SITE PLAN UPDATE

Belmont Middle and High School - Planning Board Update
May 17, 2022

ON-CAMPUS PARKING FOLLOWING COMPLETION OF PROJECT

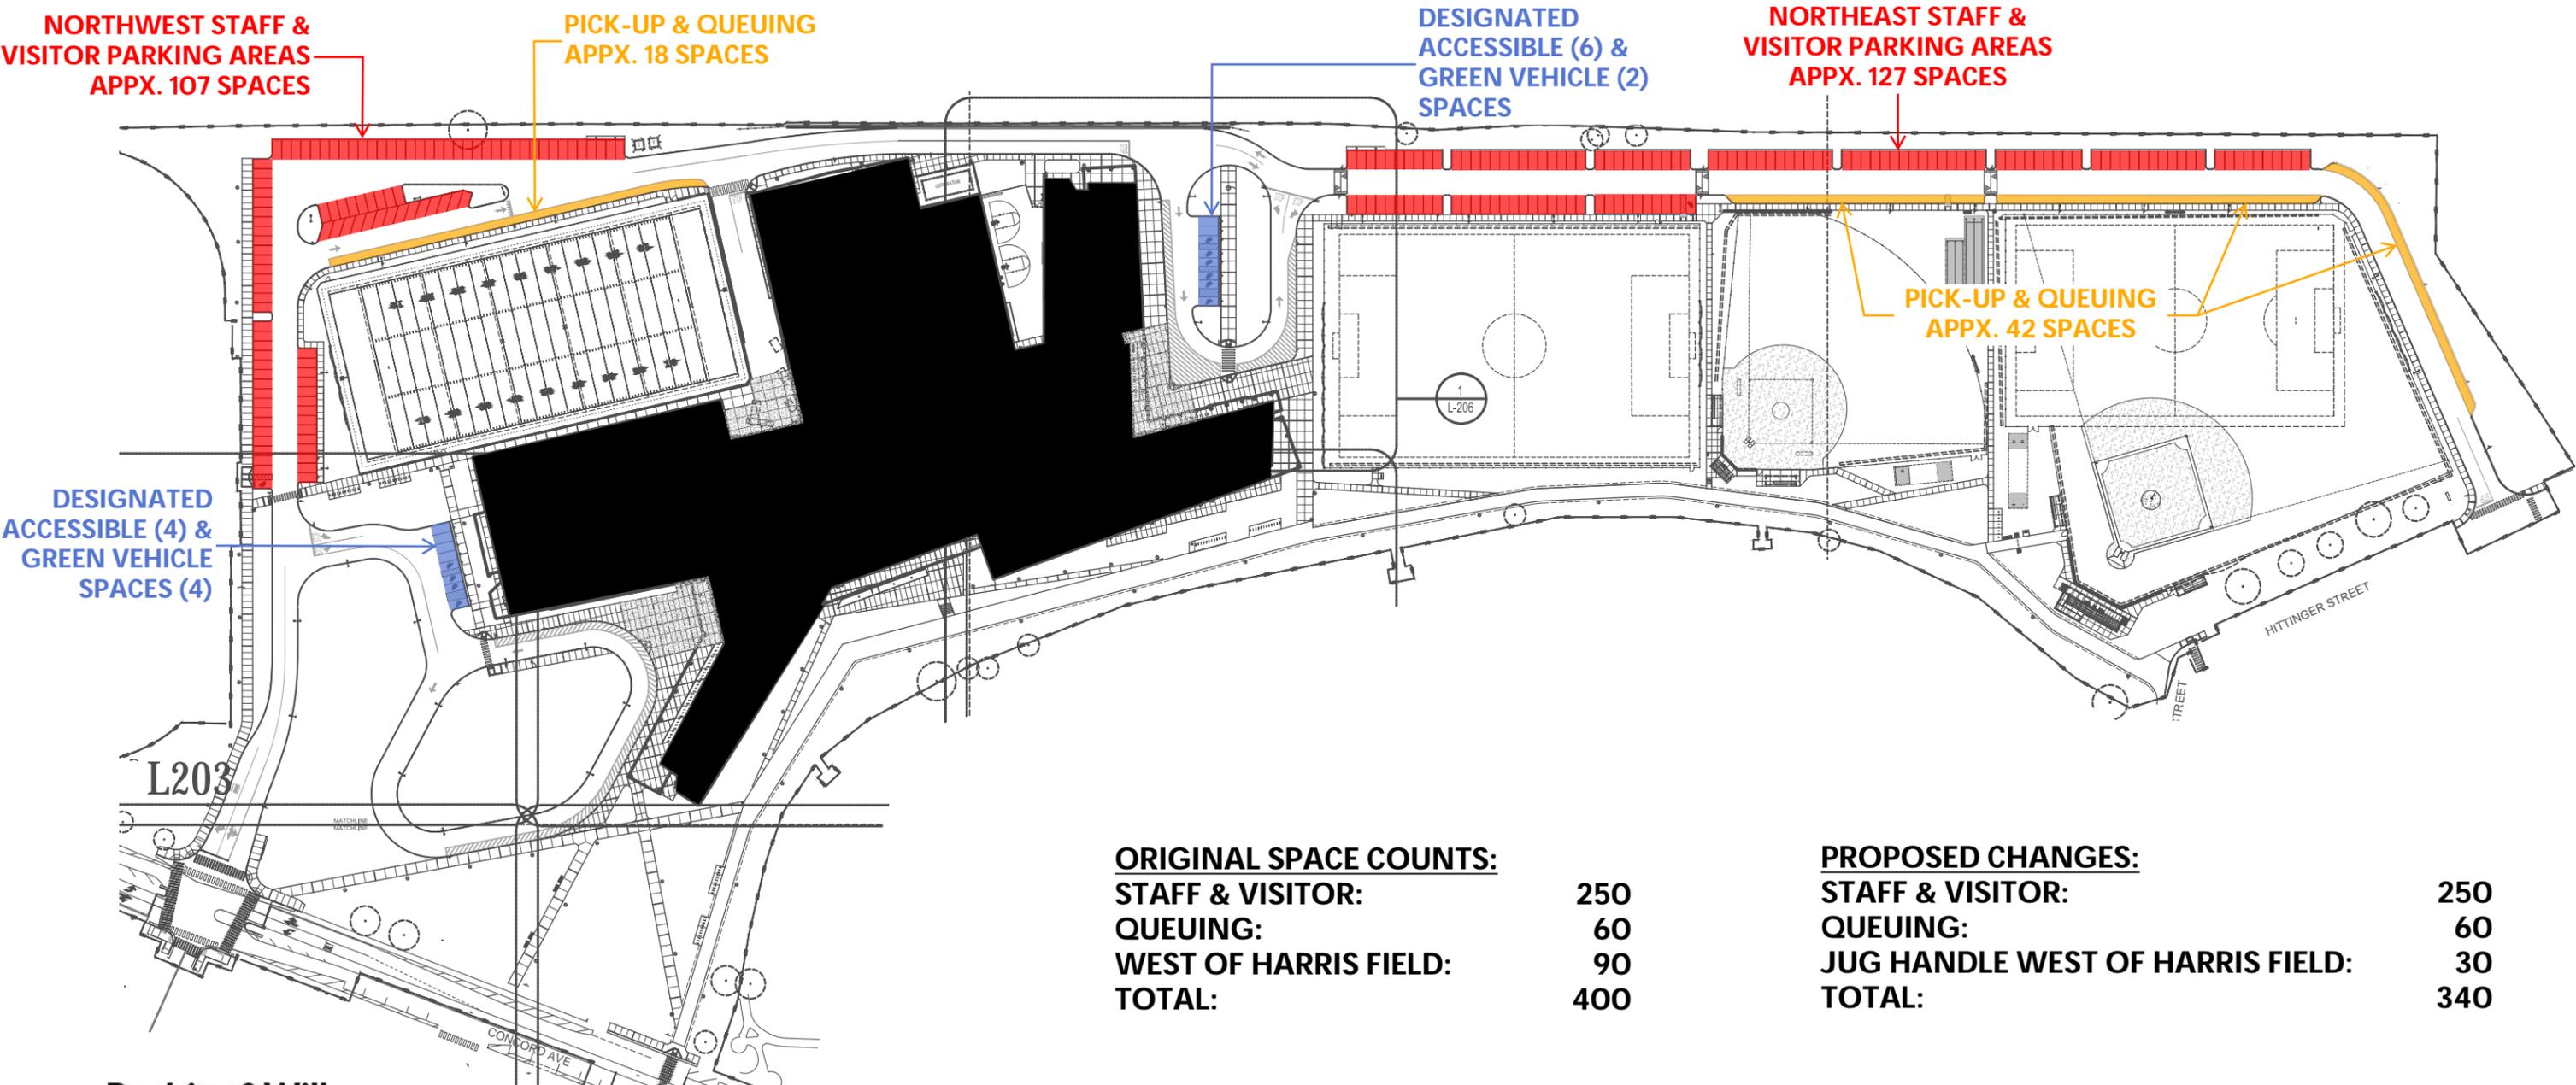
ORIGINAL SPACE COUNTS:

STAFF & VISITOR:	250
QUEUING:	60
WEST OF HARRIS FIELD:	90
TOTAL:	400

PROPOSED CHANGES:

STAFF & VISITOR:	250
QUEUING:	60
JUG HANDLE WEST OF HARRIS FIELD:	30
TOTAL:	340

REMOVAL OF SITE/CIVIL SCOPE

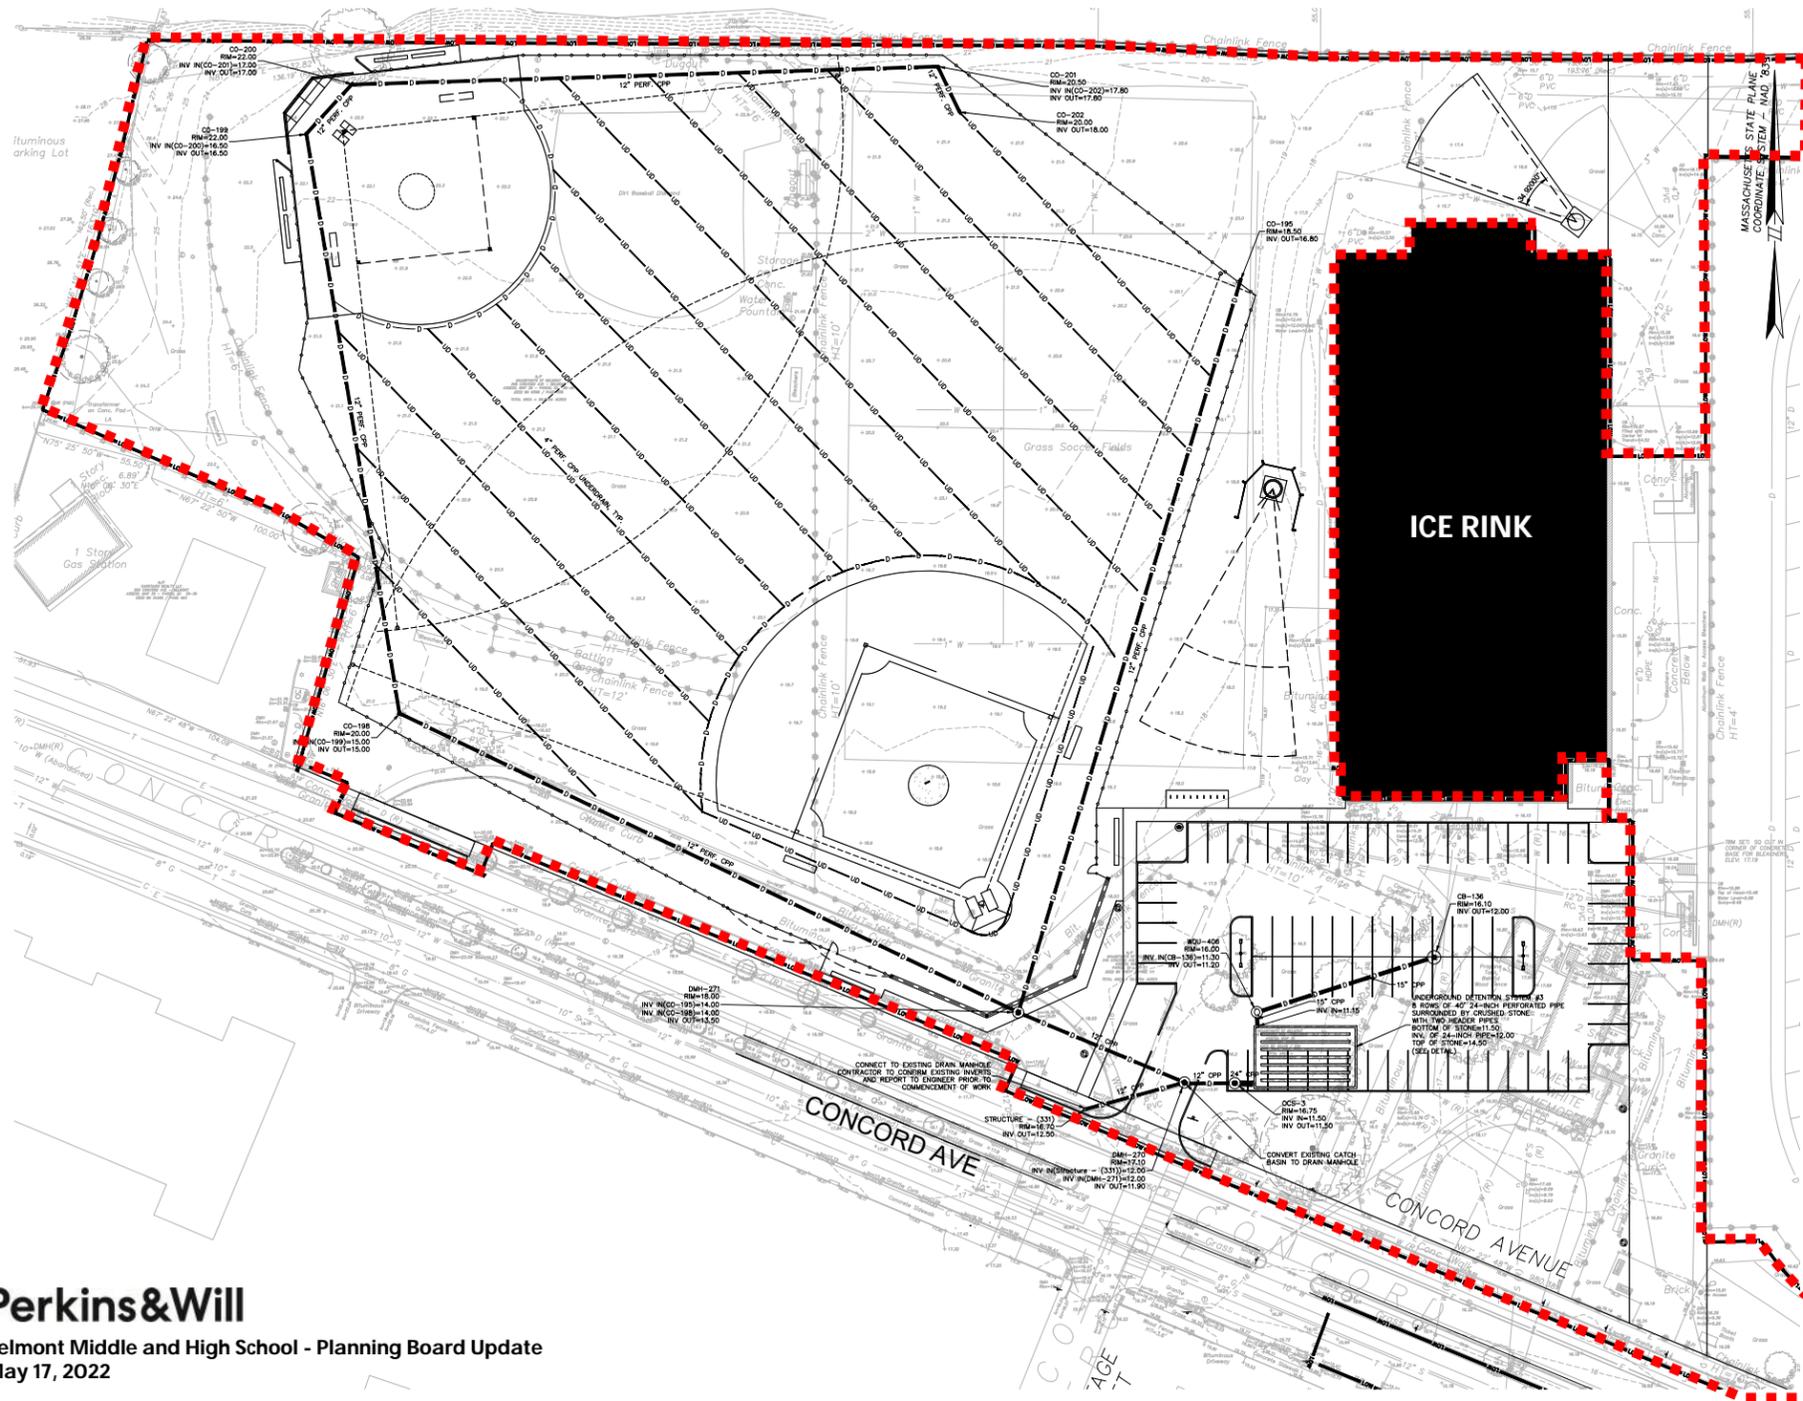
ALL WORK WITHIN
DASHED BOUNDARY
HAS BEEN REMOVED
